PRODUCT CHANGE NOTICE

PCN#22-044

Change of header platform used

From:	To:

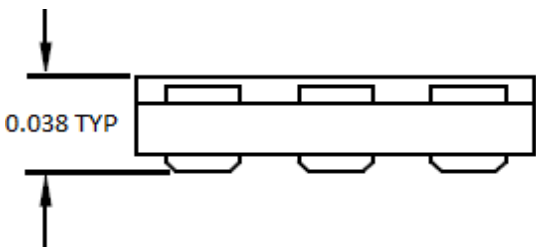
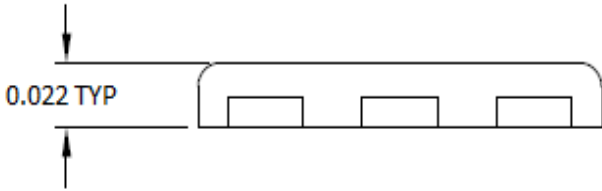
- Change to **FORM** (Appearance) and **FIT** (Dimension)
- No change to **FUNCTION** (Performance)
- Footprint compatible with reduction in overall height
- Change of surface plating from non-RoHS SnPb to RoHS compliant Matte Sn
